Planning Commission Meeting

Thursday, September 22, 2016

**Site Plan and Conditional Use Permit
Marina Pump Station
Thursday, September 22, 2016
Public Hearing**

Major Site Plan Amendment Saratoga Springs 4 Church Thursday, September 22, 2016 Public Hearing

Landscape Plan

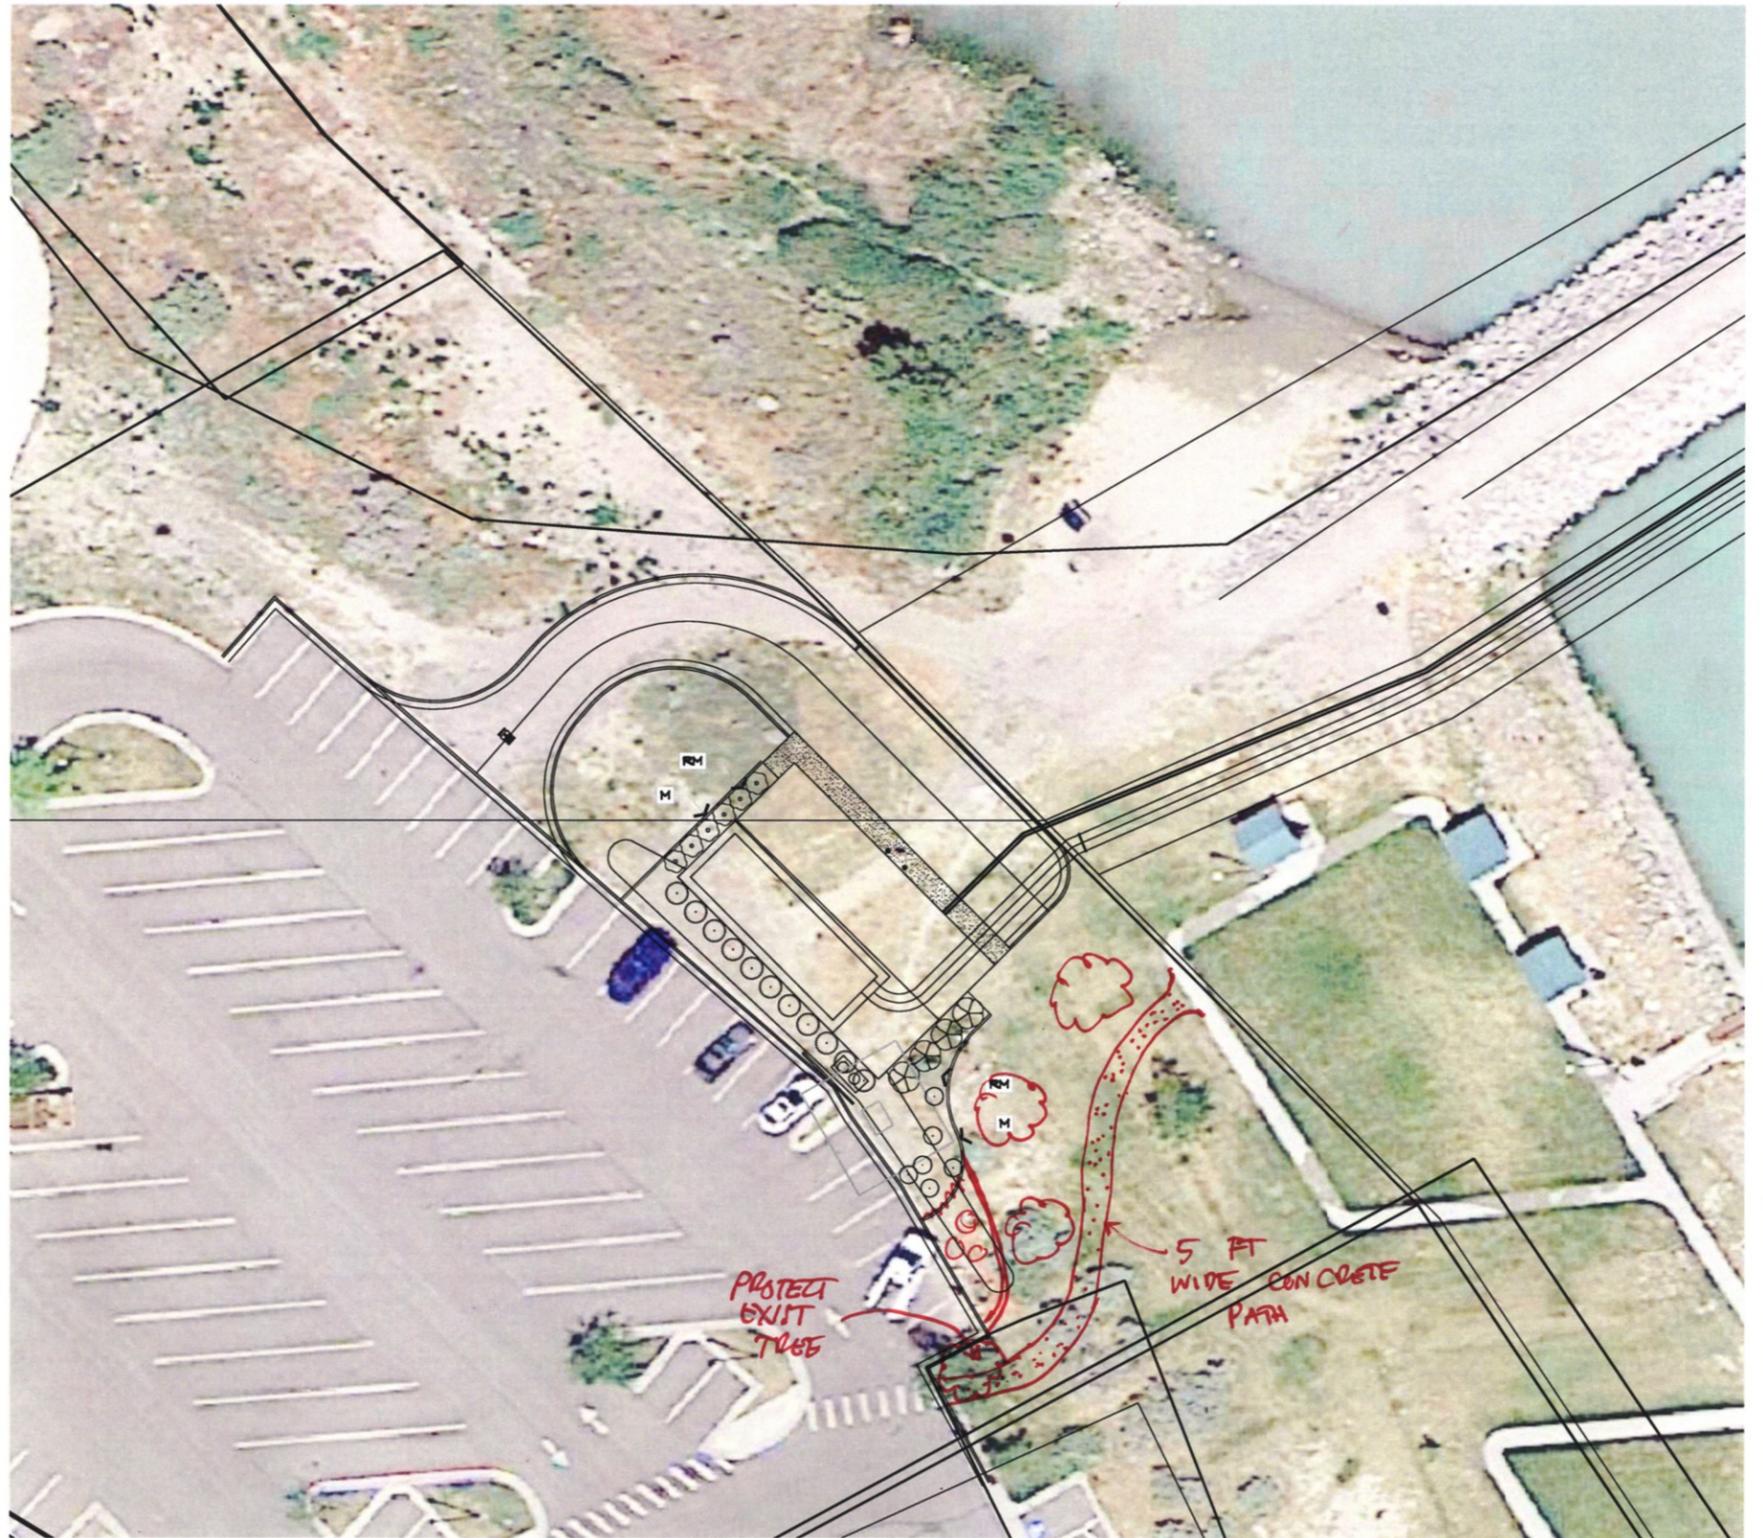
- **19.05, Supplemental Regulations – Complies.**
- **19.06, Landscaping – Can Comply.** The plans do not include a landscaping plan.
 - Staff recommends some planter beds around the building with some tall shrubs.

- No grass or trees are recommended at this time.
 - A draft landscape plan is attached; a landscape and irrigation plan is needed.
- **19.09, Parking – Can Comply.** The parking requirements shall be determined by the Planning Commission. Staff does not recommend any parking stalls for this site as it will be accessed from the adjacent parking lot.

- Provide a landscape plan with some xeriscaping and some trees.
 - A draft plan is attached; a final plan will be presented at the meeting.
 - It was noted that this is a tall building.

1. All conditions of the City Engineer shall be met.
2. A landscape and irrigation plan shall be submitted that includes planter beds around the building with tall shrubs and possibly trees and xeriscape.
3. Any other conditions or changes as articulated by the Planning Commission:
